CITY OF ALBUQUERQUE

RE: **Lot 18 Block 8 Unit 22 Volcano Cliffs SAD 228**
6309 Alderete Ct. NW
Grading and Drainage Plan
Engineers Stamp Date 3/22/17 (D10D003E18)

DRAINAGE AND TRANSPORTATION INFORMATION SHEET (REV 09/2015)

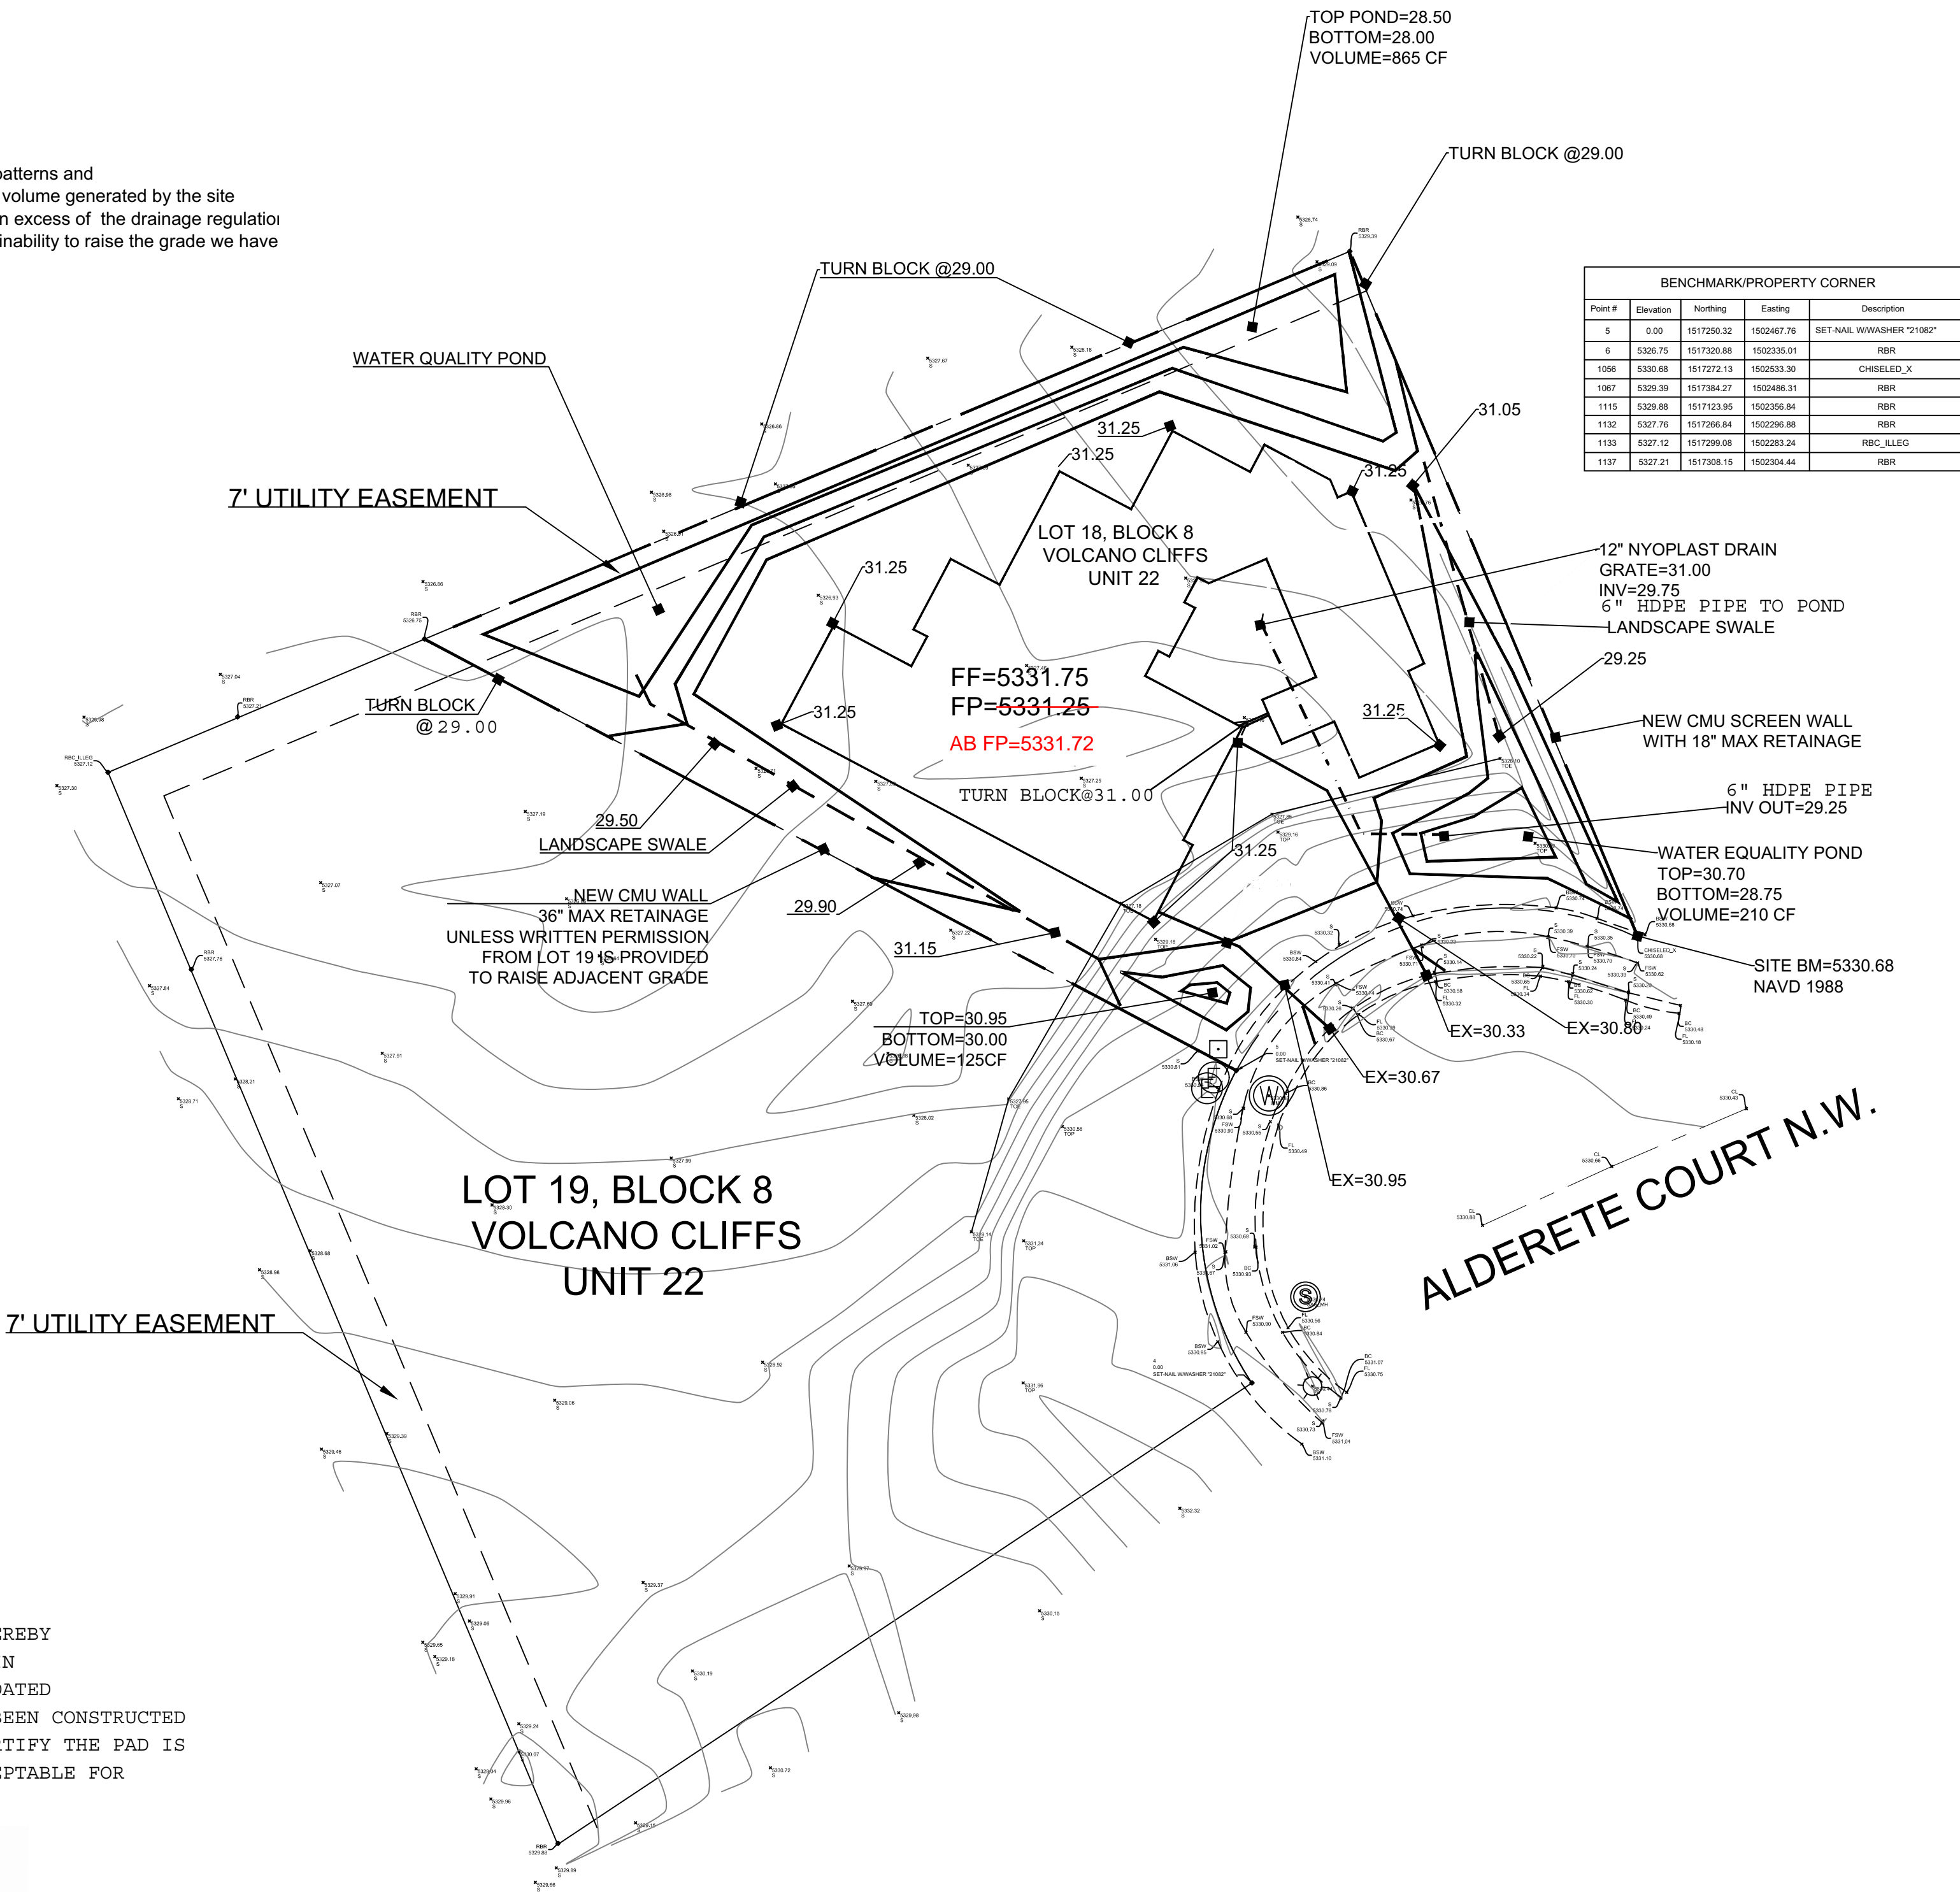
Based upon the information provided in your submittal received 3/28/17, this plan is approved for Grading Permit. **Prior to building permit approval, a pad certification will be required.** A hold on the property will be placed until this certification has been approved.

Please inform the builder/owner to attach a copy of this approved plan to the construction sets in the permitting process prior to sign-off by Hydrology. Reiterate to the Owner/Contractor that a separate permit for a garden/retaining wall must be obtained, with the approved G&D plan dated 3/22/17.

Prior to Certificate of Occupancy release, Engineer Certification per the DPM checklist of this plan will be required.
